Revision - June 29, 1954

PUNAHOU SEPARATION

MAUKA ARTERIAL

SHEET No. 1 OF 8 SHEETS

5627.72

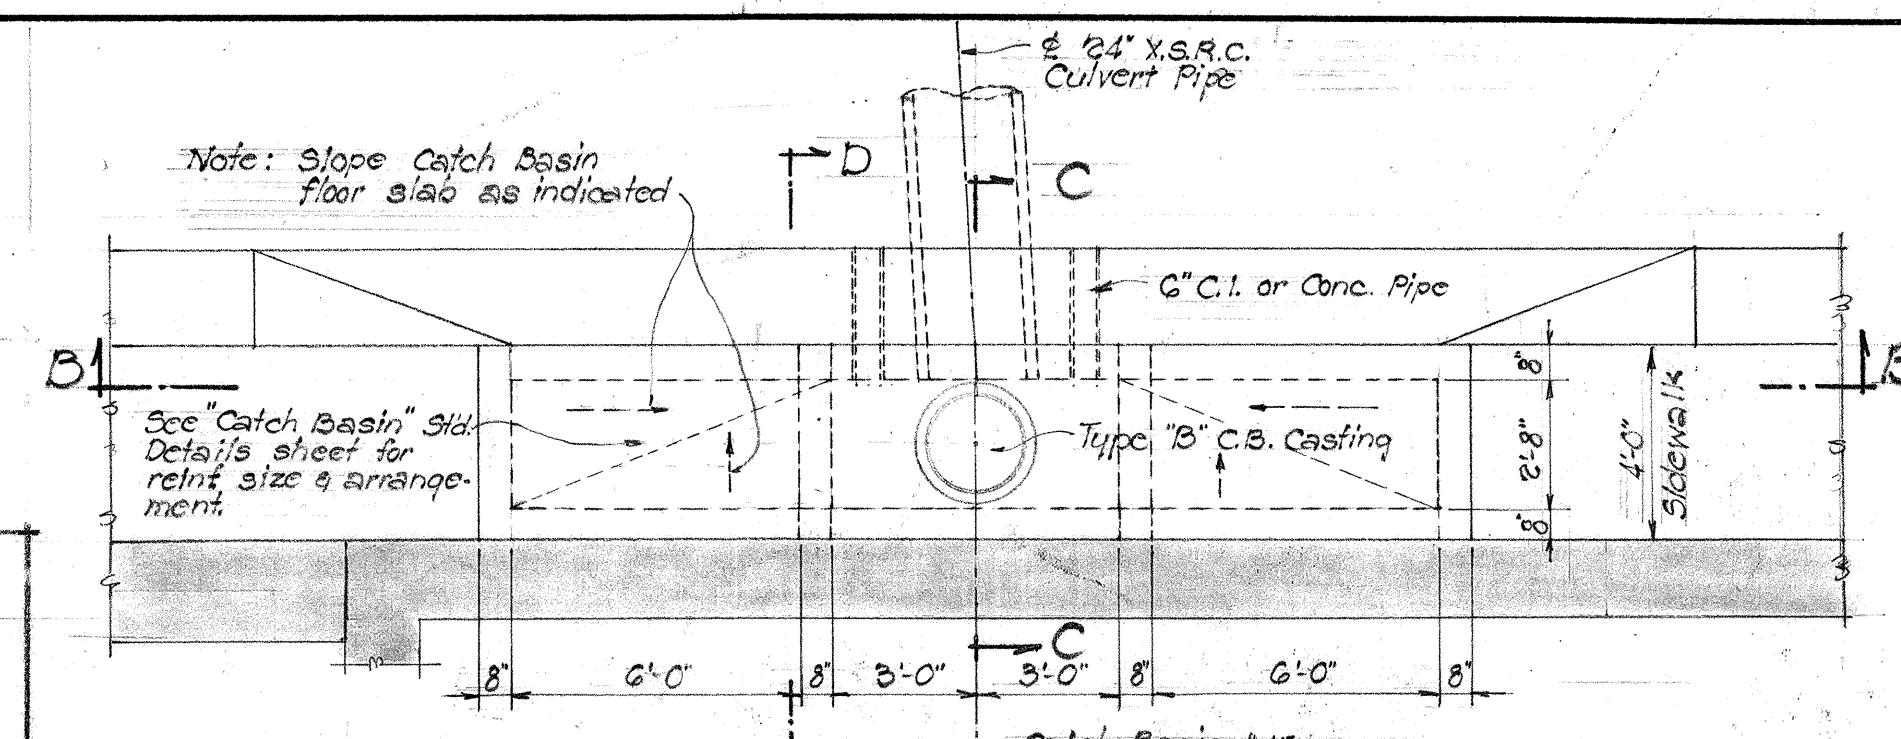
Revision: June 29, 1954
Top of Counterfort elevation at Est. Wall No. I corrected.
